ADDENDUM 1 – JOB 39

TO: All prospective bidders on project SOIB-CPU-7-023(050)910, Job No. 39 scheduled for the November 17, 2017 bid opening.

**ADDENDUM 1
JOB NO. 39**

TO: All prospective bidders and suppliers on Project SOIB-CPU-7-023(050)910, Job No. 39 in McKenzie County, scheduled for the November 17, 2017 bid opening.

Revised	10/31/17	STATE	PROJECT NO.	SECTION NO.	SHEET NO.
		ND	SS-7-023(050)910	60	8

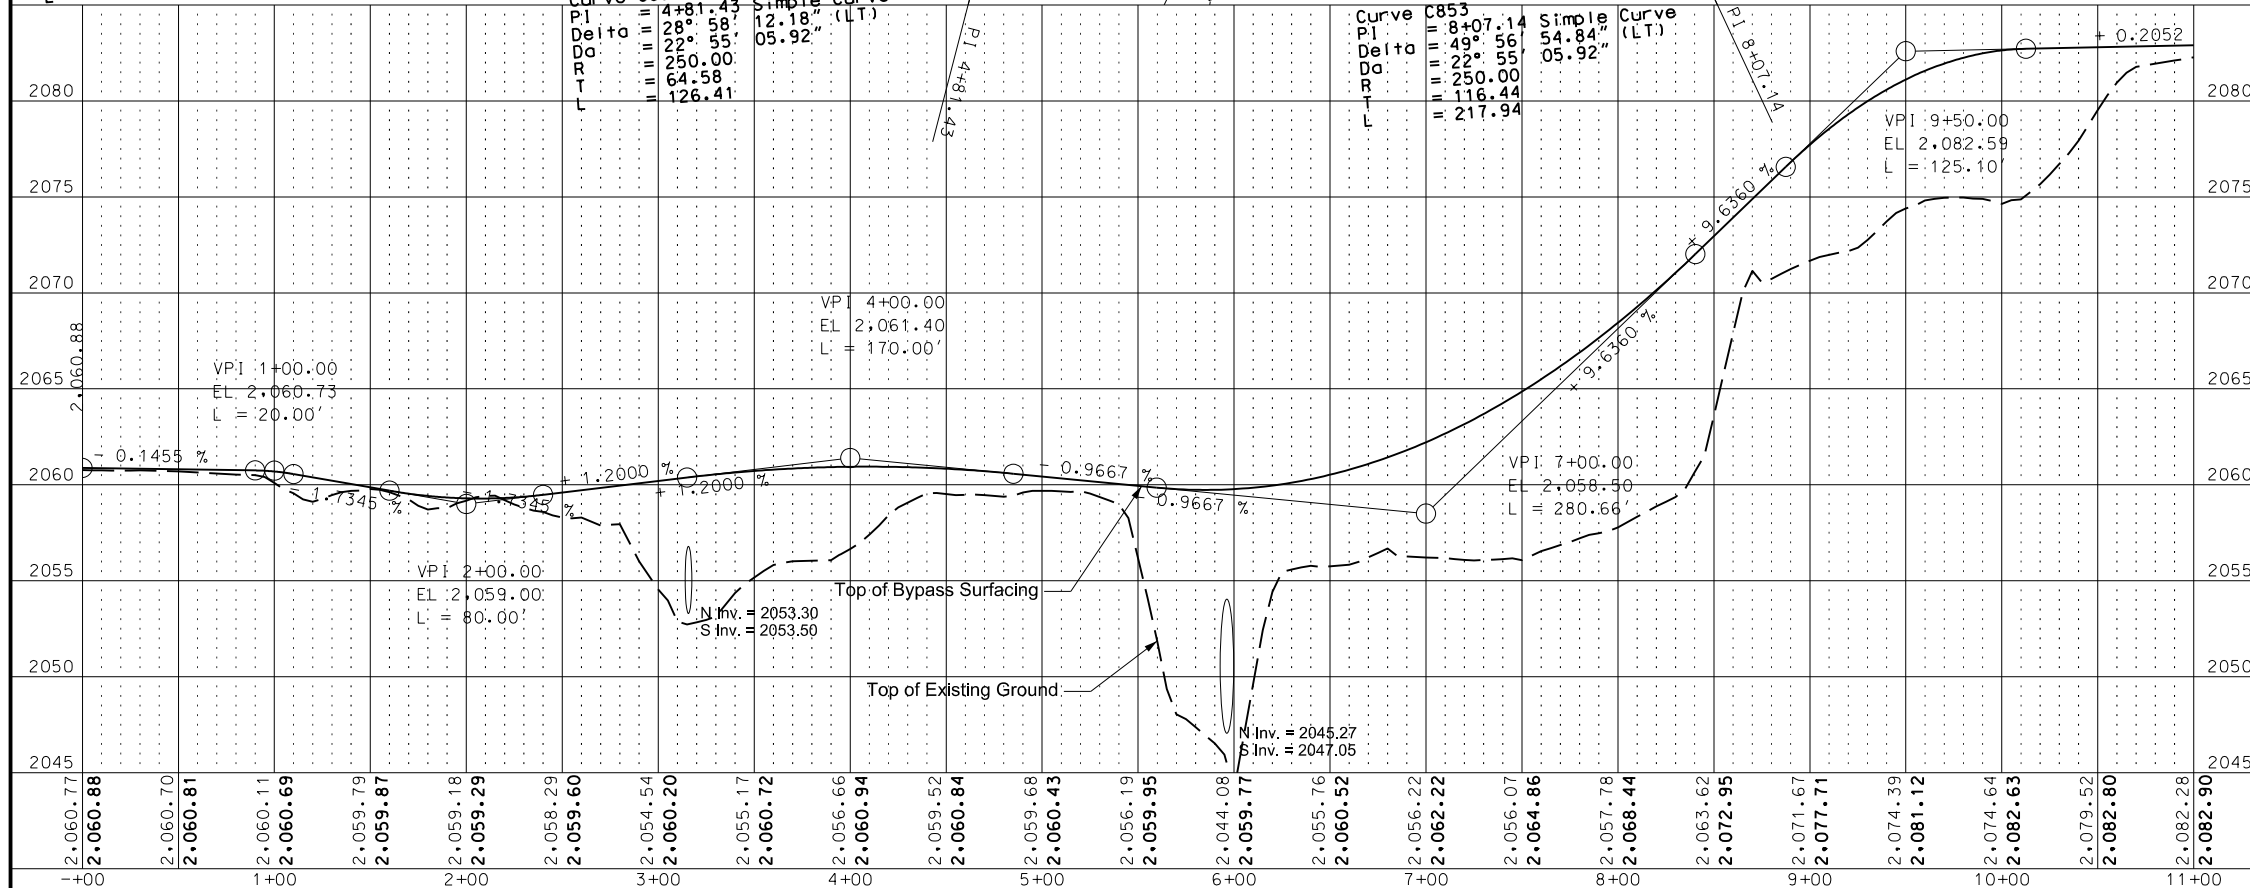
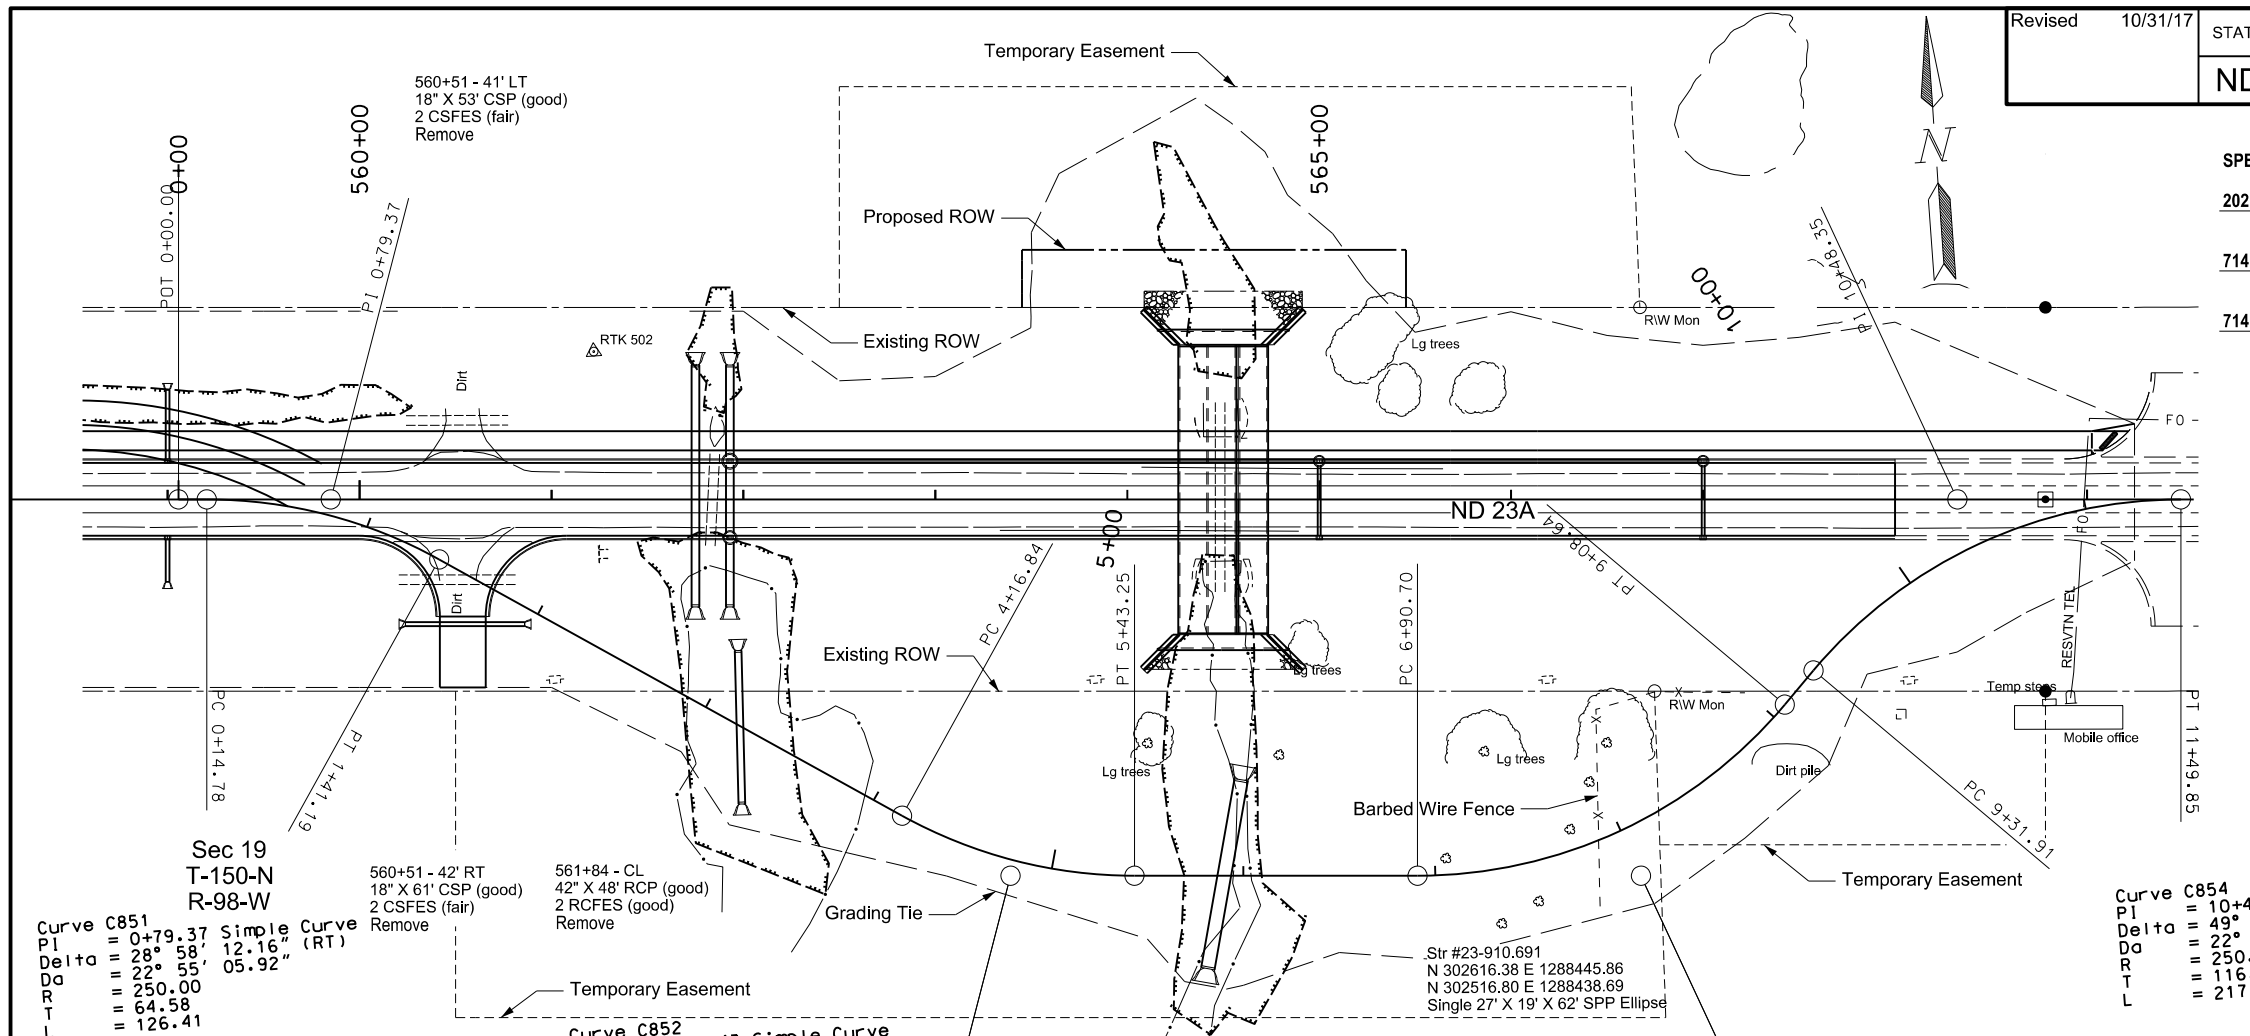
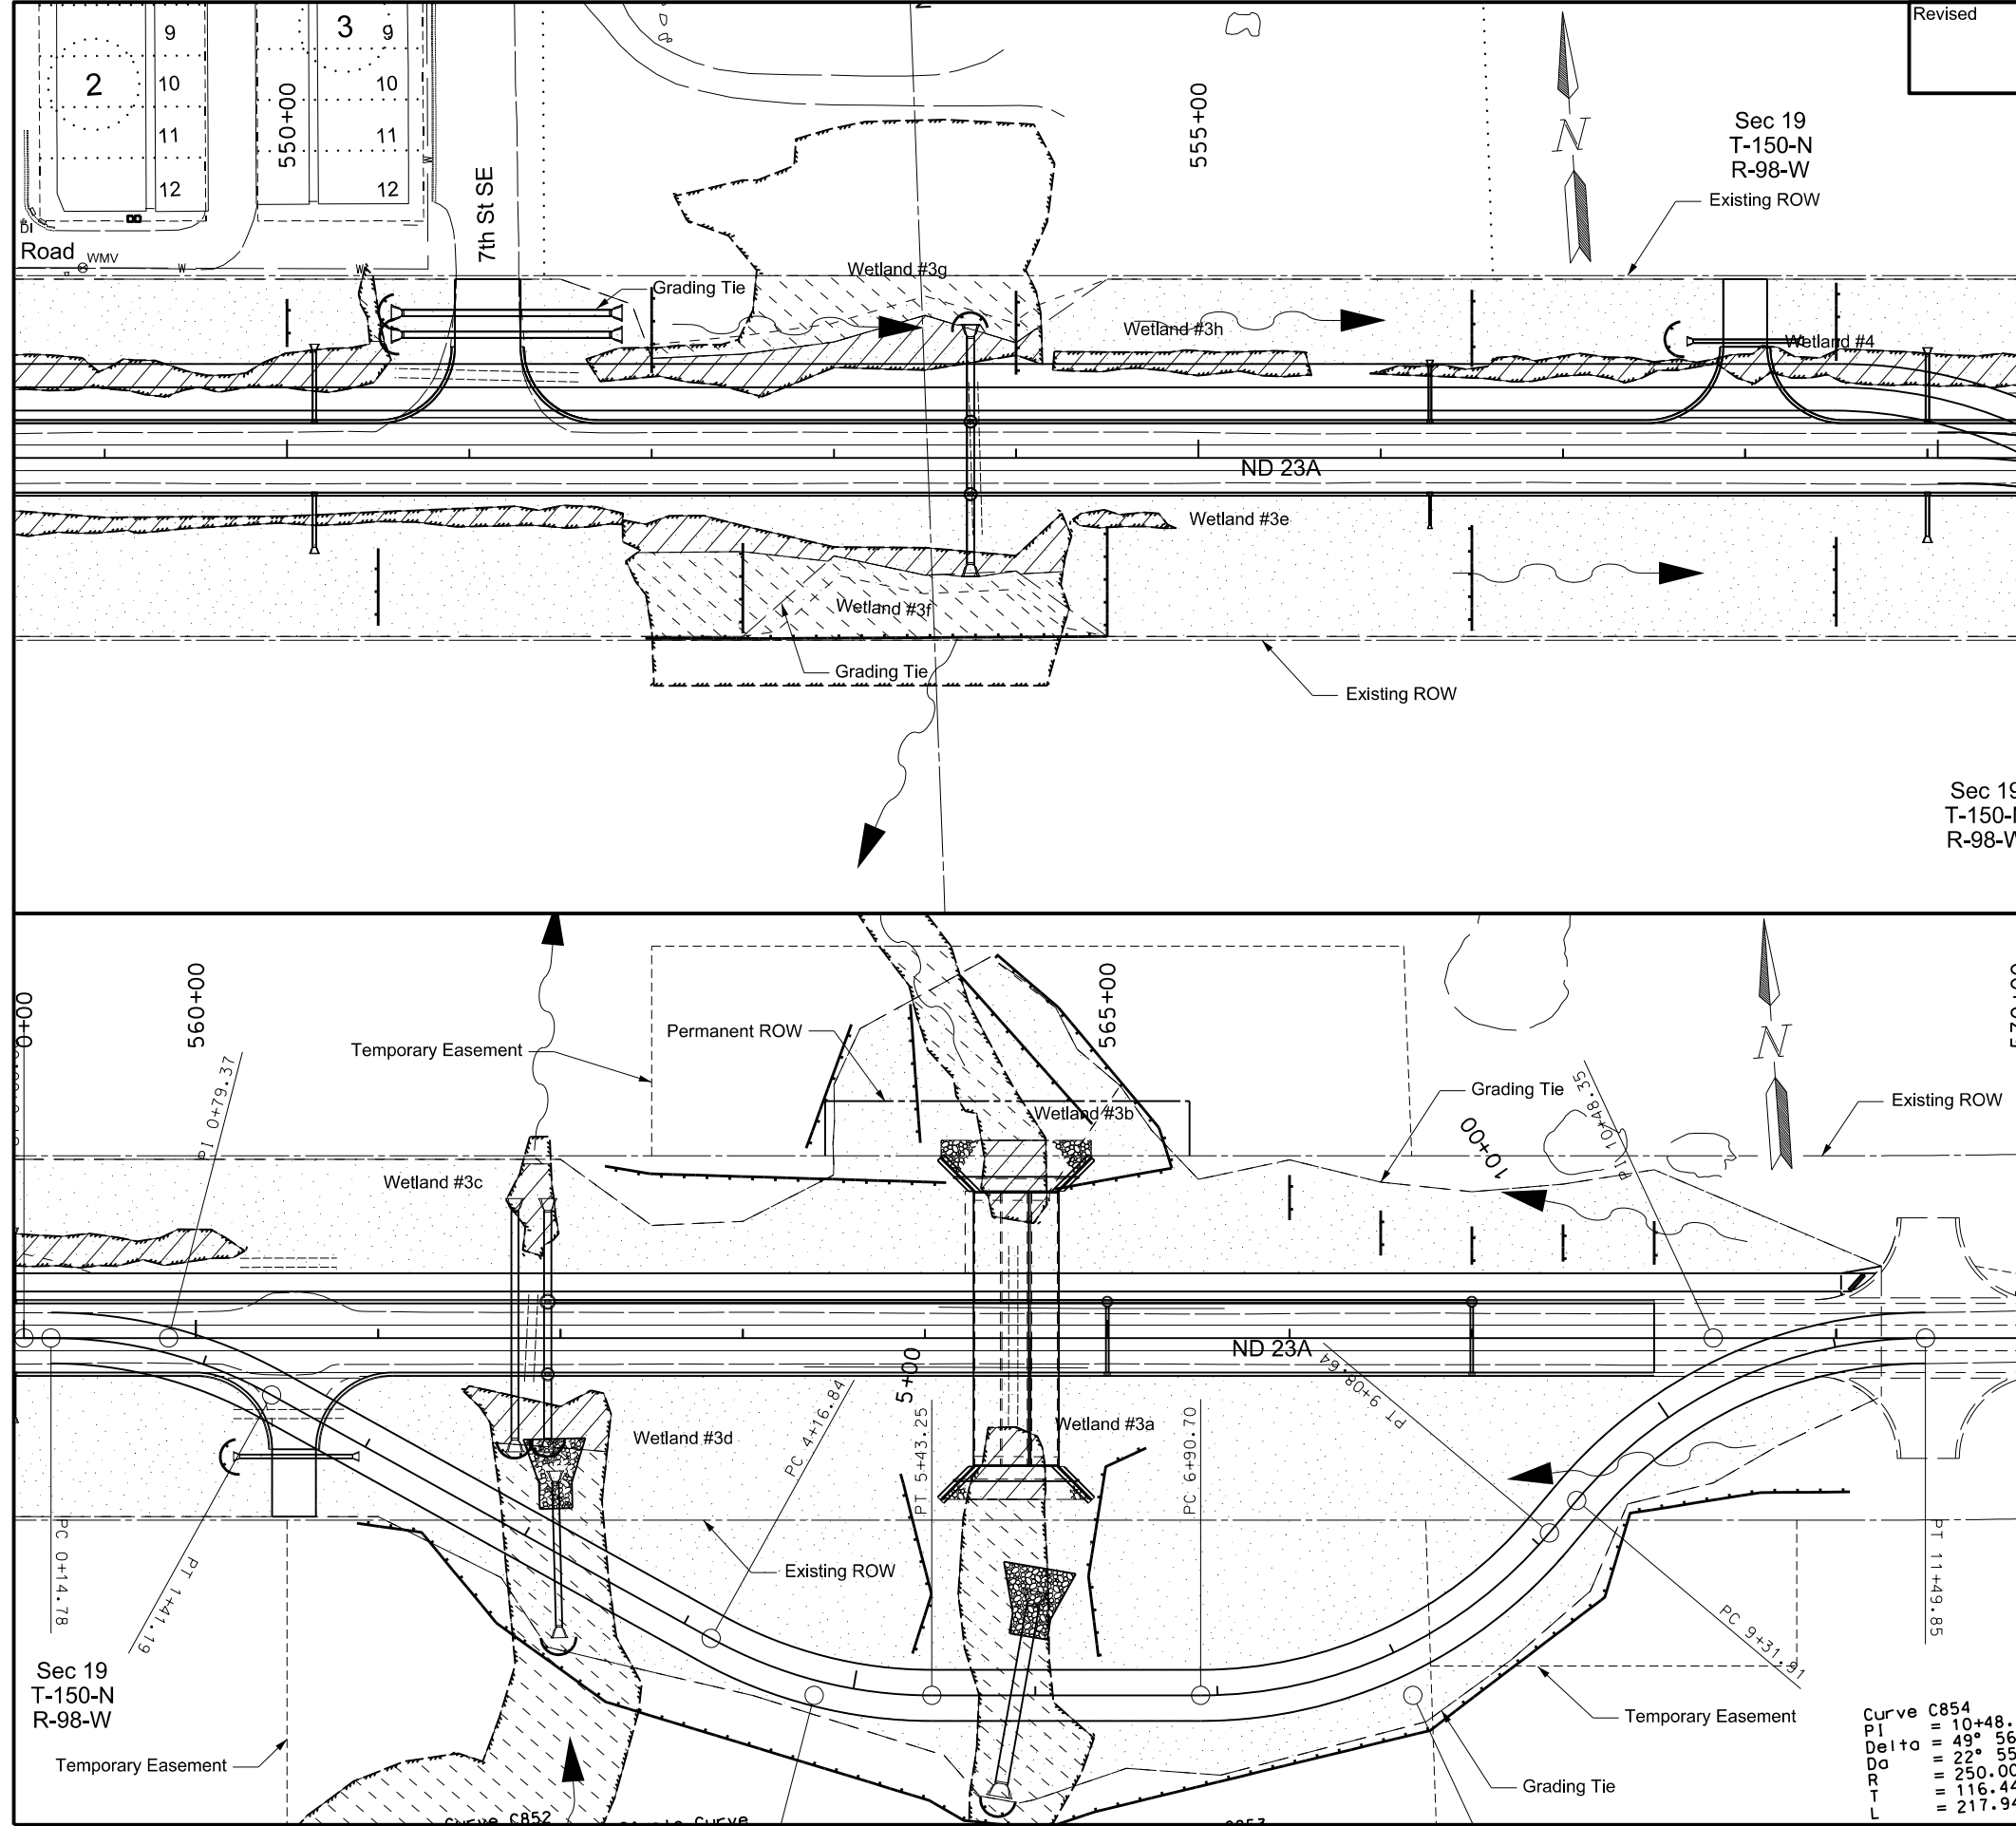
- Section 60, Sheet 8: The horizontal and vertical alignment for the temporary bypass were updated. The bid item for Remove & Reset Fence was changed to Remove Existing Fence.
